COLORADO CENTRE METROPOLITAN DISTRICT ADMINISTRATION BUILDING - SITE DEVELOPMENT PLAN

PCD File No. PPR-21-51

EPC STORMWATER REVIEW COMMENTS
IN ORANGE BOXES WITH BLACK TEXT

COLORADO CENTRE METROPOLITAN DISTRICT
ADMINISTRATIVE BUILDING - SITE DEVELOPMENT PLAN
GRADING & EROSION CONTROL PLAN

FOREBAY CROSS-SECTION N.T.S.

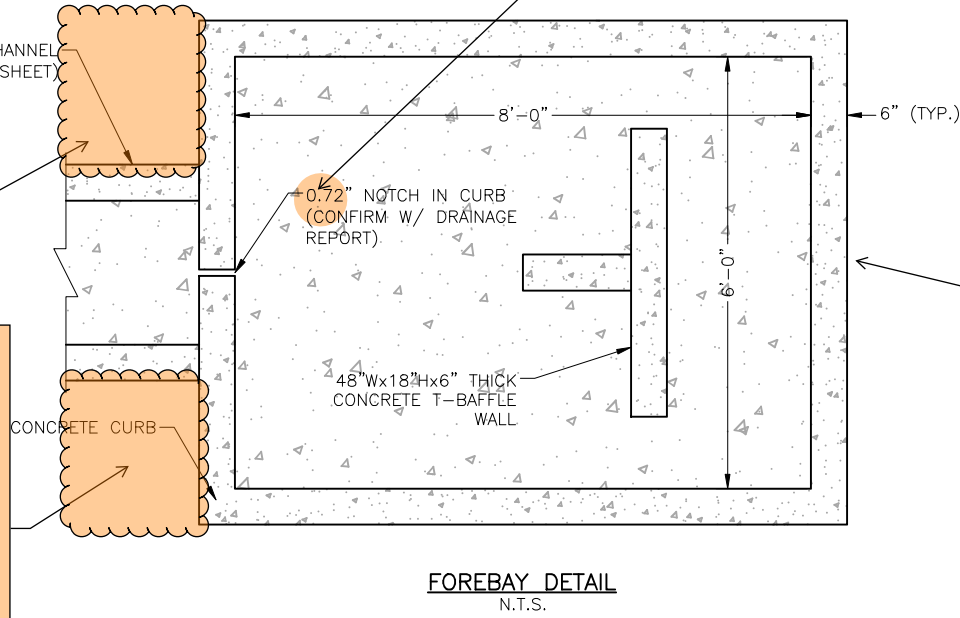
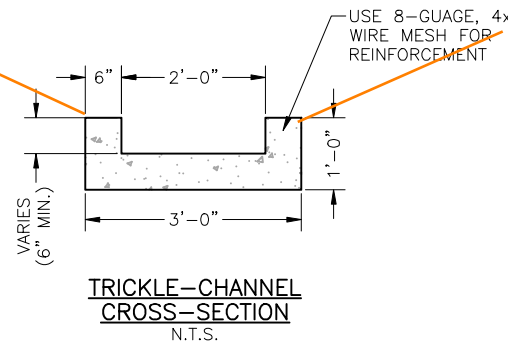
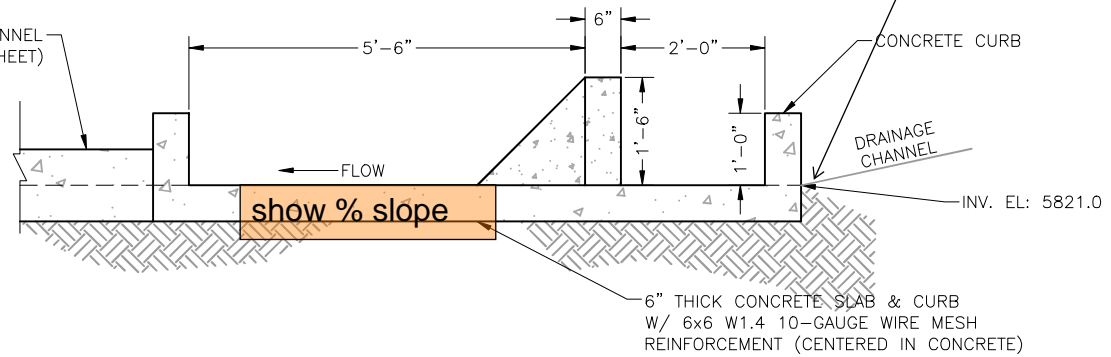
comments were generated based on newly provided pond details

confirm elevation with MHFD Detention Spreadsheet

does not match DR

how will flows enter forebay?

Soil riprap should also be provided on the downstream side of the forebay berm or wall if the downstream grade is lower than the top of the berm or wall. The forebay will overtop frequently so this protection is necessary for erosion control. All soil riprap in the area of the forebay should be seeded and erosion control fabric should be placed to retain the seed in this high flow area. (MHFD T-5)

Pond bottom should have a minimum slope of 3% to the trickle channel and micropool (USDCM Vol 3, detail T-5).
